Contract #: 04-0120F4Cty: SF/ALA Rte: 80 PM: 13.2/13.9File #: 69.25B**QUALITY ASSURANCE -- NON-CONFORMANCE REPORT****Location:** ZPMC Changxing Island - Shanghai, China**Report No:** NCR-000013**Prime Contractor:** American Bridge/Fluor Enterprises, a JV**Date:** 15-Oct-2007**Submitting Contractor:** Zhenhua Port Machinery Company, Ltd (ZPMC), Changxing Island**NCR #:** ZPMC-0012**Type of problem:**

Job Name: SAS Superstructure

Subject: NCR No. ZPMC-0012

Reference Description: Repairs to skin plate welds greater than 10% in length on the 114m Mock-up

项目名称 Project Name	美国海湾大桥 SFOBB	部件图号 Drawing No	MUSC-MA109	报告编号 Report No.	CWR010
合同号 Contract No.:	04-0120F4	部件名称 Items Name	STIFFENER OF 114M SKIN E	NDT报告编号 Report No. of NDT	CT-UT-016
项目编号 Project No.:	ZP06-787

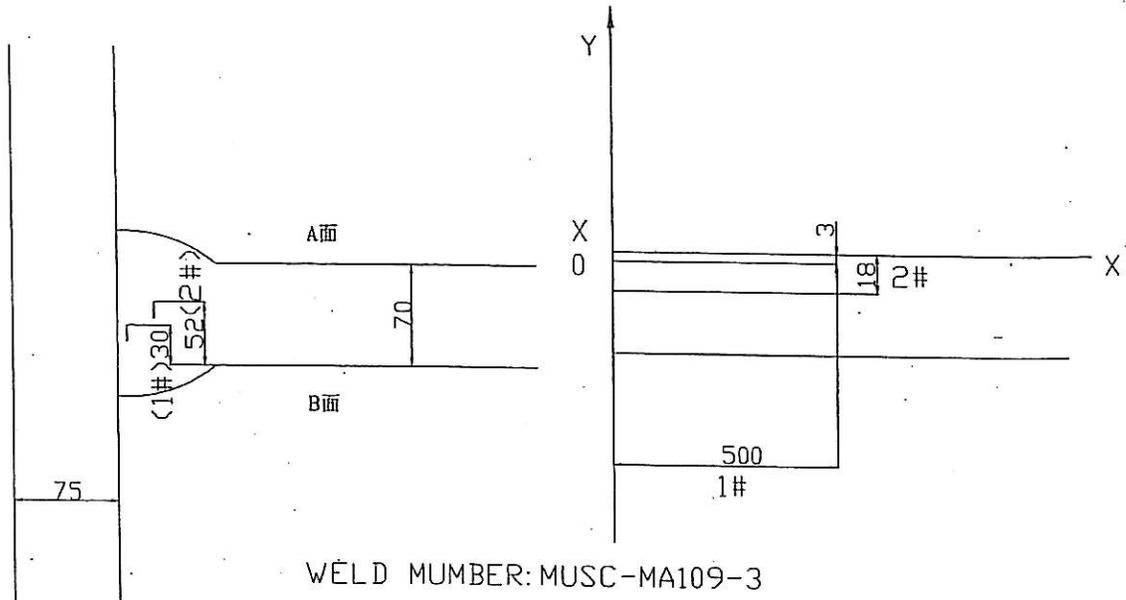
Rejected indication found by ultrasonic inspection exceeds 10% of the weld size. MUSC-MA109-3

1. 焊道没有清除干净。
2. 返修深度错误。
1. Did not clear the weld pass completely.
2. Depth of repair had mistakes.

Repair welding shall be in according with the attached Stiffener to Skin Plate CJP welding Procedure and an approved WPS. Revisions to the Mockup Fabrication Procedure are currently in process and shall reflect the revisions adopted by the attached Stiffener to Skin Plate CJP welding procedure.
